SPARE PARTS LIST

560 XP/XPG

Illustrated part list IPL update

H560XP/XPG

A 560XP
CHAIN BRAKE & CLUTCH COVER

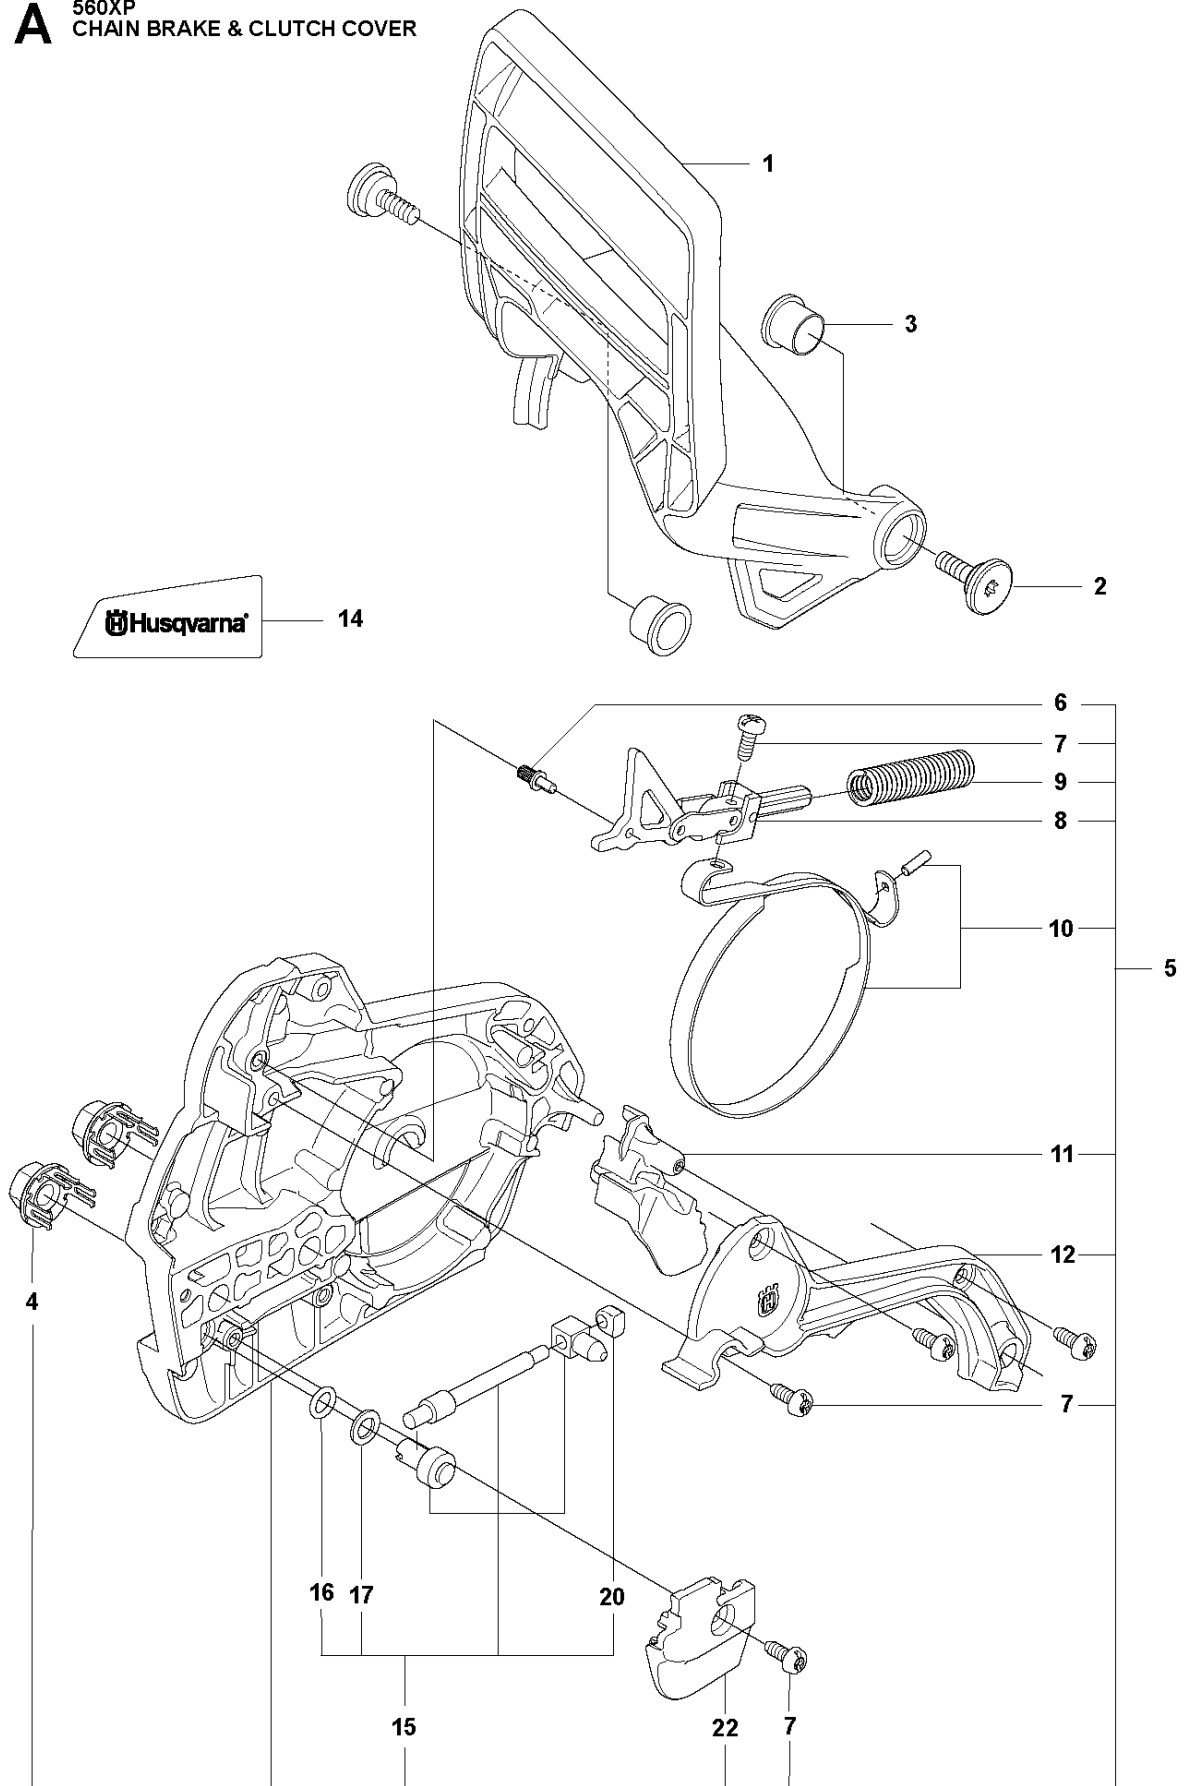
1. We have removed the label 535 05 80-01 on Clutch cover assy and added a moulded logo "Husqvarna". New colour: **Metallic Rough**.
2. New forged adapter has been implemented on the Clutch drum, the new Worm wheel has a new design due to this new adapter. The old Worm wheel 505 20 08-01 will **NOT** fit the new Clutch drum, and new Worm wheel will **NOT** fit the old Clutch drum.
3. New Oil pump 505 19 99-08 with increased diameter has been introduced to fit the new Clutch drum. New colour: **Natural**.

1. Clutch cover assy 501 84 61-01 is fully exchangeable. New colour: **Metallic Rough**.
2. Clutch drum and Worm wheel are **NOT** exchangeable.
3. Oil Pump is fully exchangeable. New colour: **Natural**.

B 560XP/XPG
CLUTCH & OIL PUMP

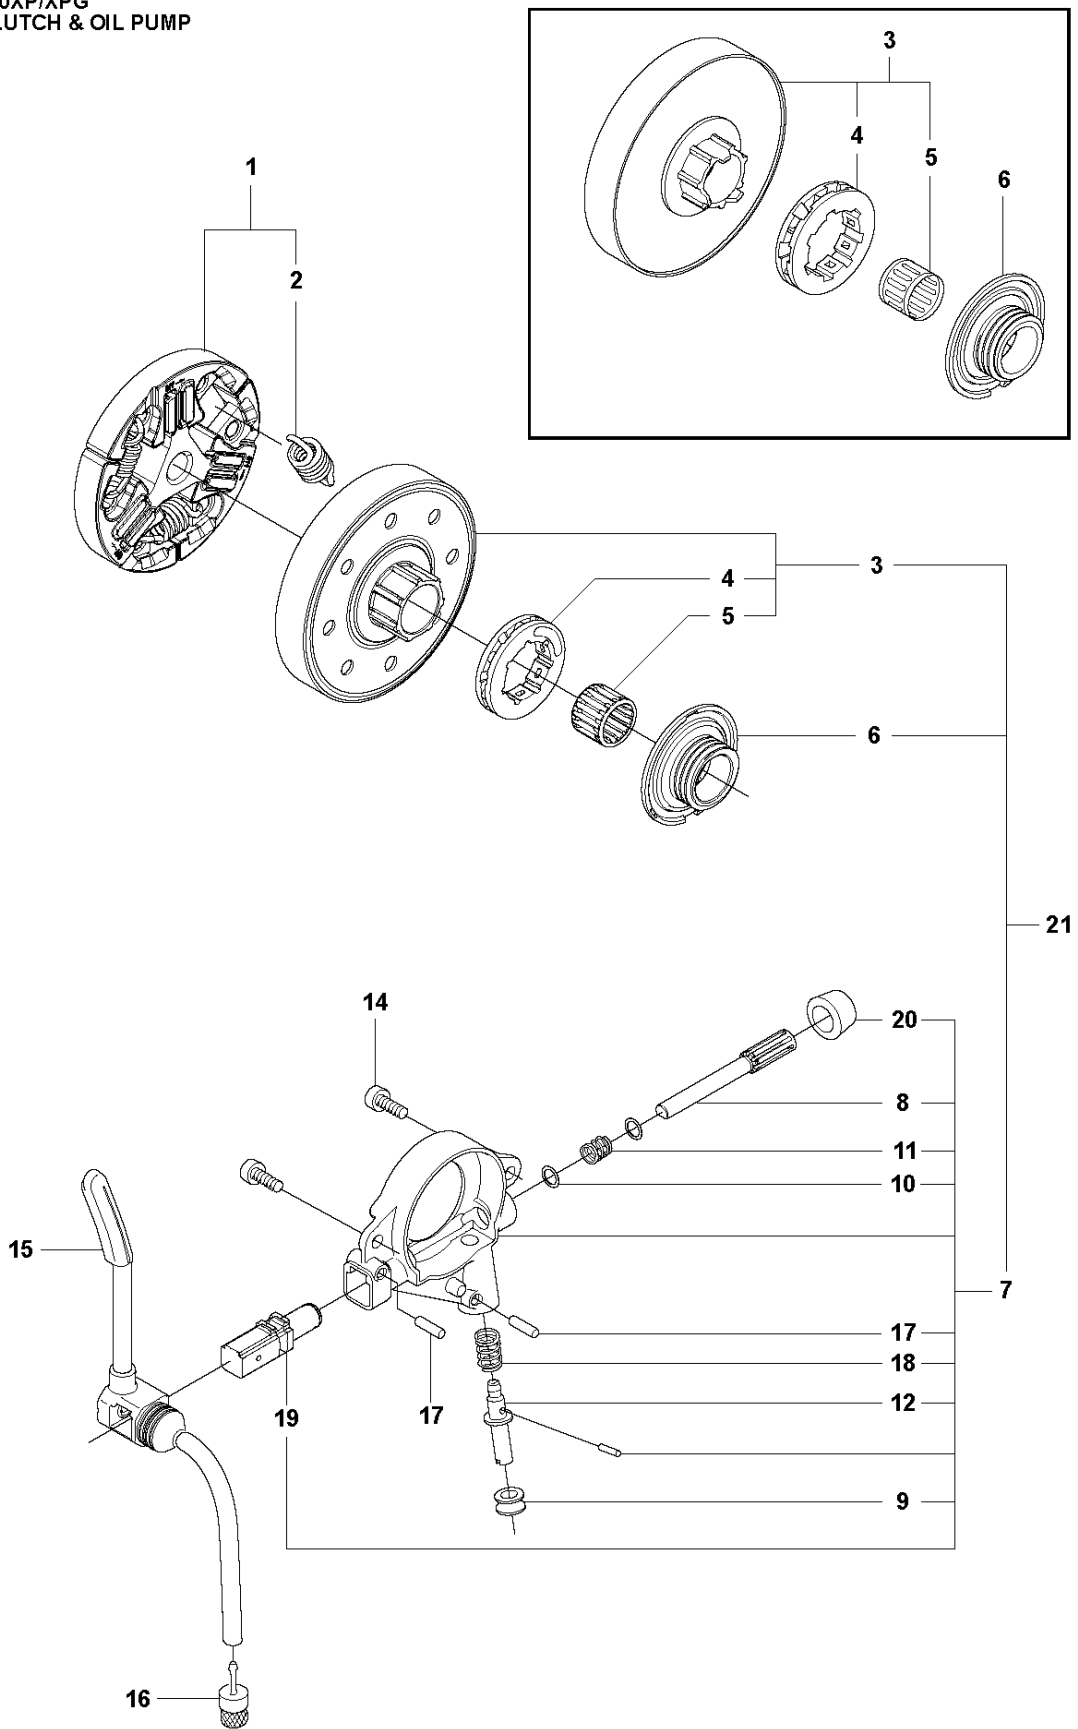
New Clutch drum assy Kit, 598 93 77-01/-02 is added. The Kit consist of: The new Clutch drum assy, new Oil pump and new Worm wheel.

Clutch drum assy kit 598 93 77-0-01/-02 is fully exchangeable.

CRANKSHAFT

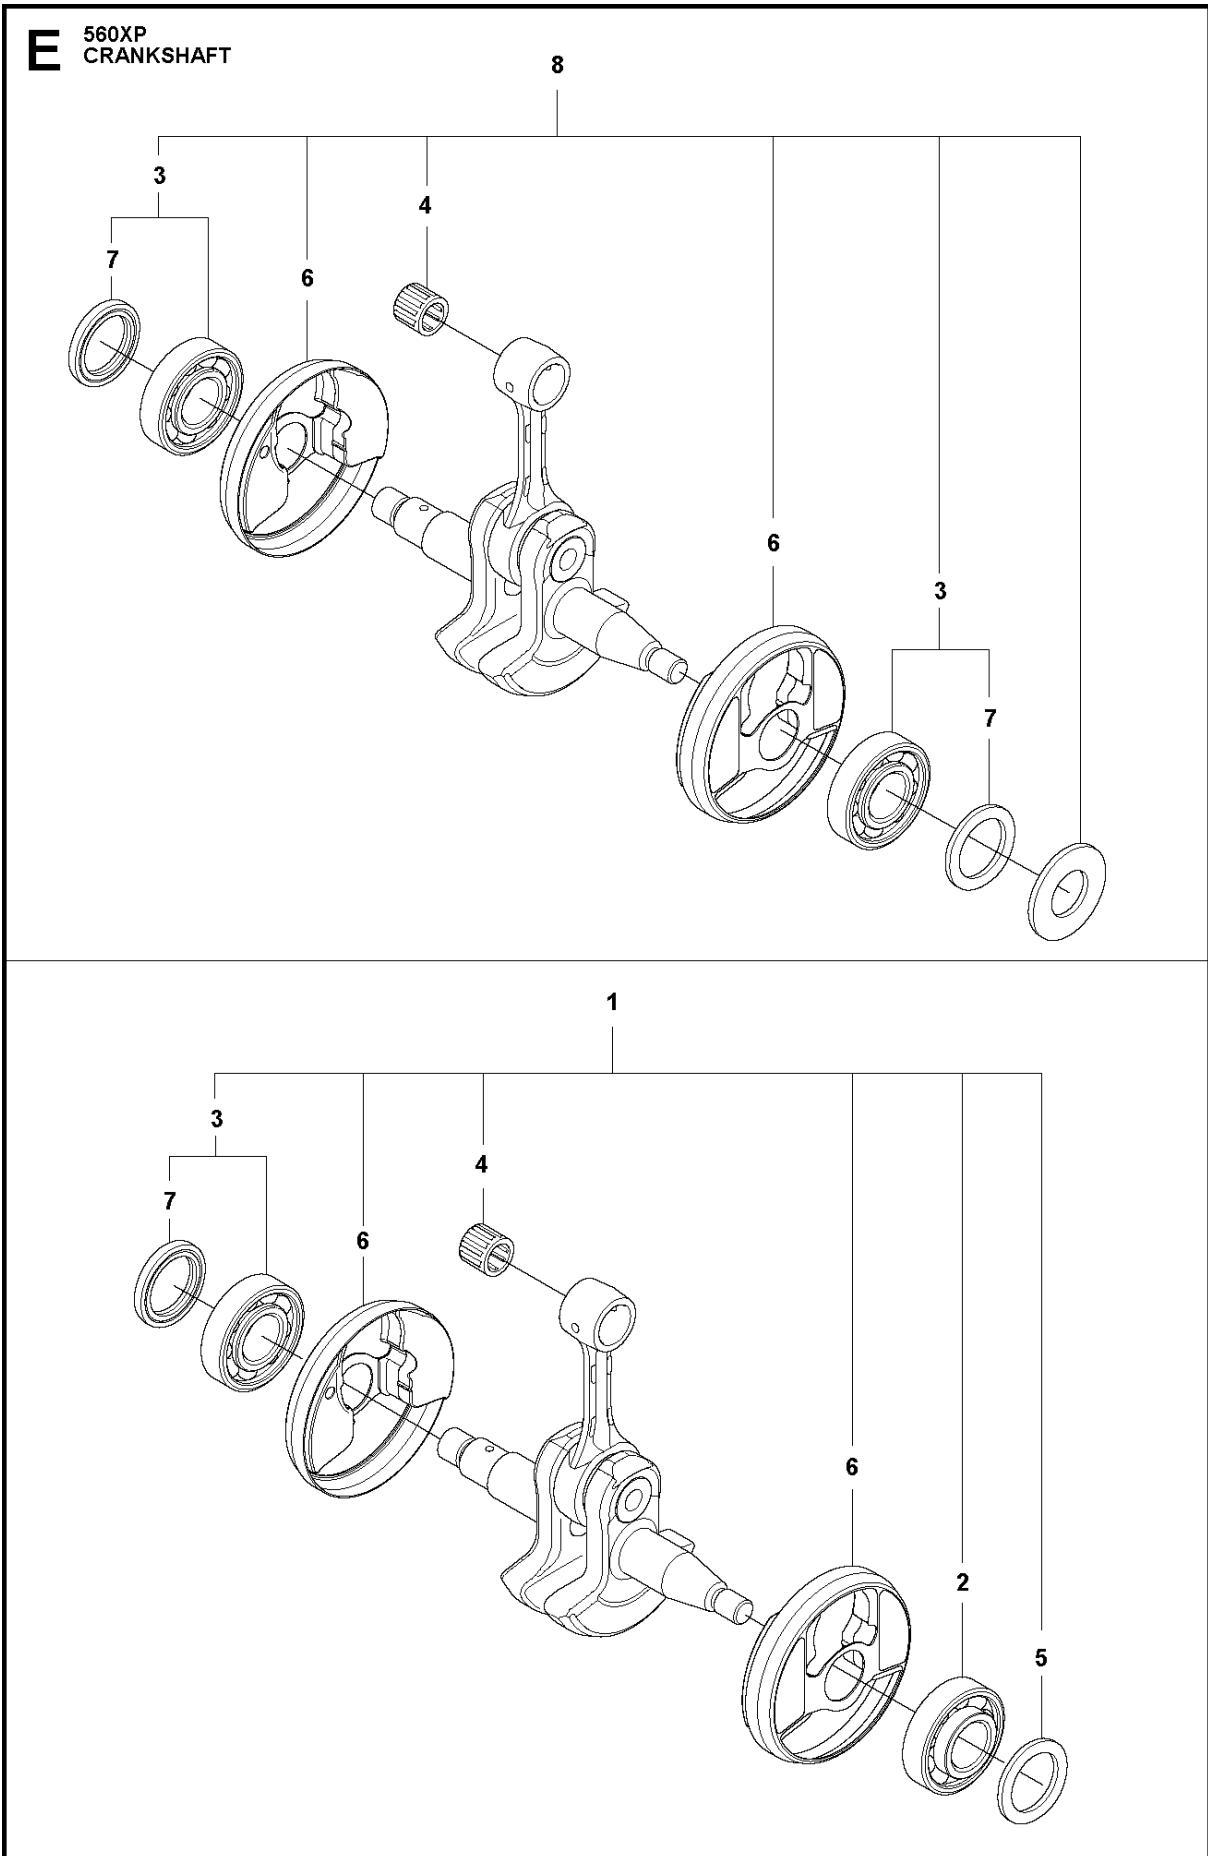
4. A new Ball bearing 525 43 42-04 is replacing -03. New Crankshaft 575 54 52-17 has an additional Ball bearing 525 43 42-04 and a Protective cap 596 91 13-01.
5. A new Crankcase assy 575 38 02-22 has been implemented with a new Fly wheel side and an additional Ball bearing 525 43 42-04. New colour: **Metallic Rough**.

4. Ball bearing 525 43 42-04 is fully exchangeable with 525 43 42-03.
Ball bearing 525 43 42-04 is **NOT** fully exchangeable with 505 13 35-03.
5. Crankcase assy 575 38 02-22 and Shortblock 580 66 37-11 are fully exchangeable.
New colour: **Metallic Rough**.
6. Protective cap is **NOT** fully exchangeable. **NOTE:** Only for use on new Crankcase 575 38 02-22 and Shortblock 580 66 37-11.

H2 560XP
CRANKCASE SHORT BLOCK

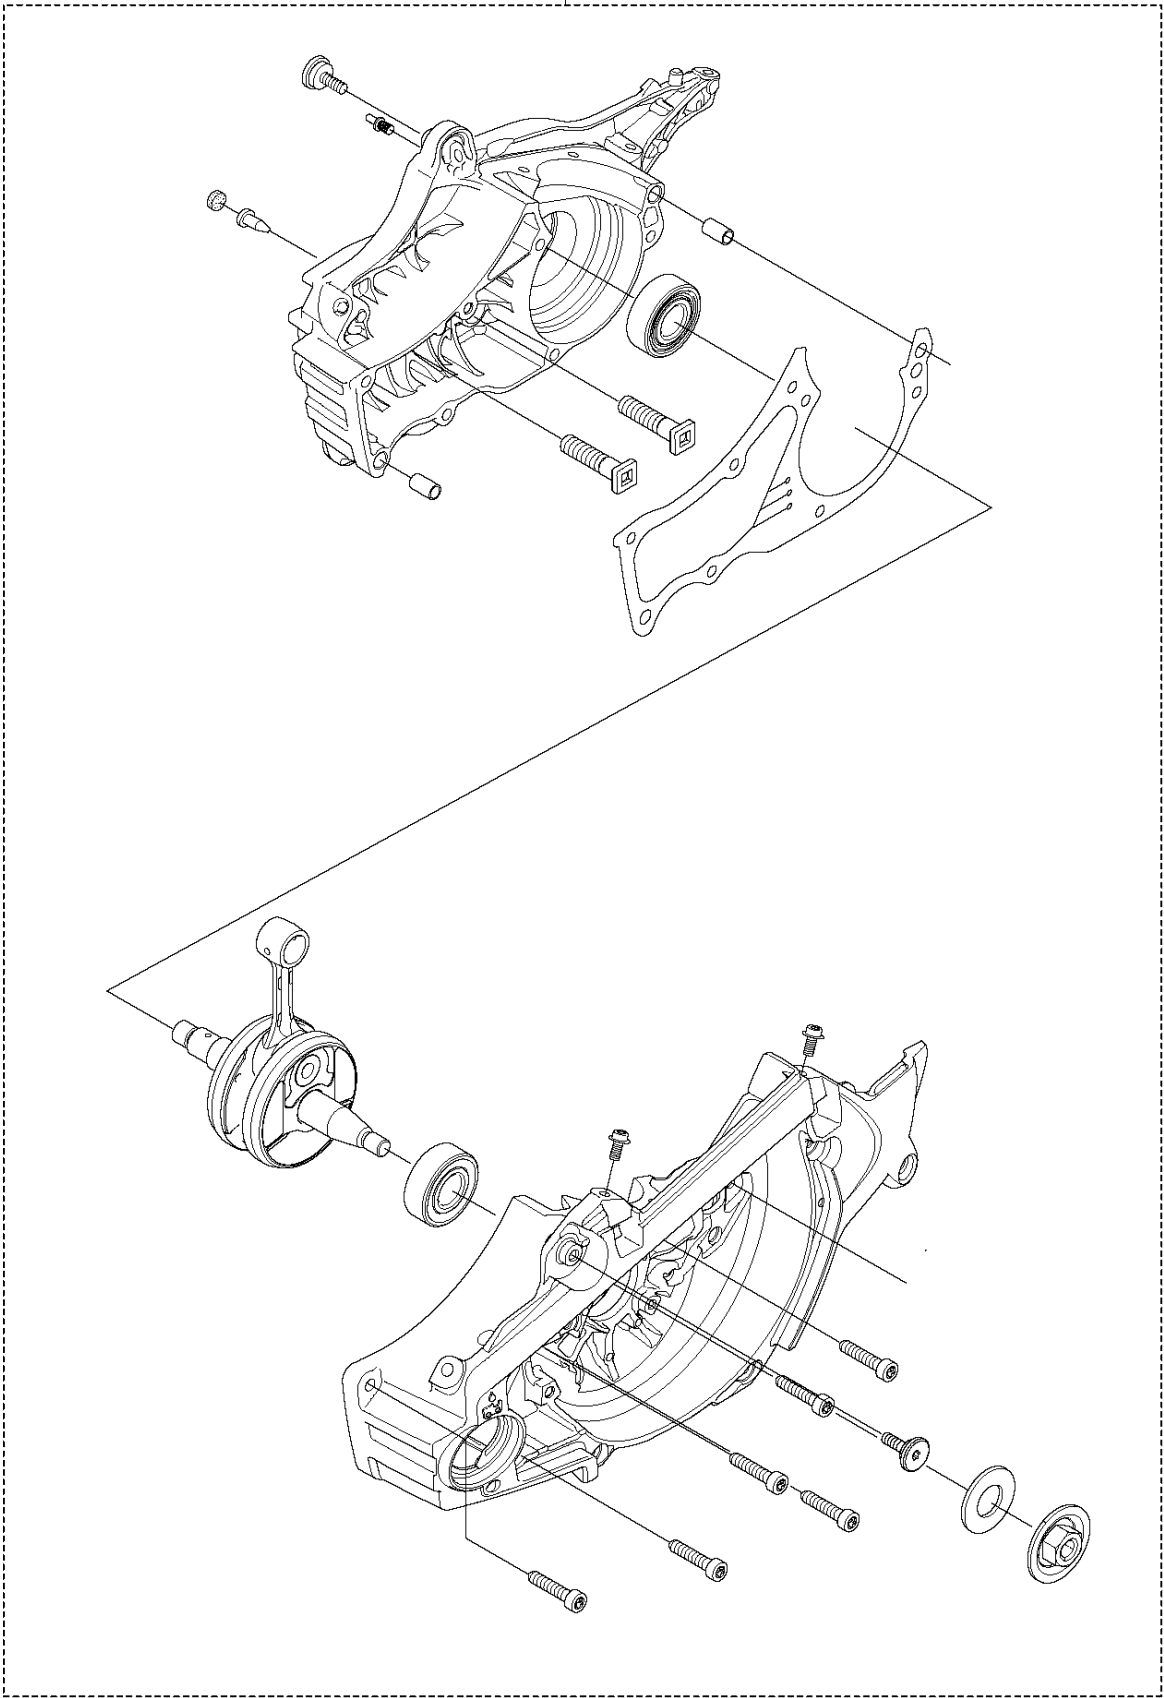
Page H2 added with Shortblock 580 66 37-11.

6. We have introduced a Protective cap 596 91 13-01 to prevent dirt from getting into the crankcase. **NOTE:** Can only be used on new Crankcase assy 575 38 02-22 and Shortblock 580 66 37-11.
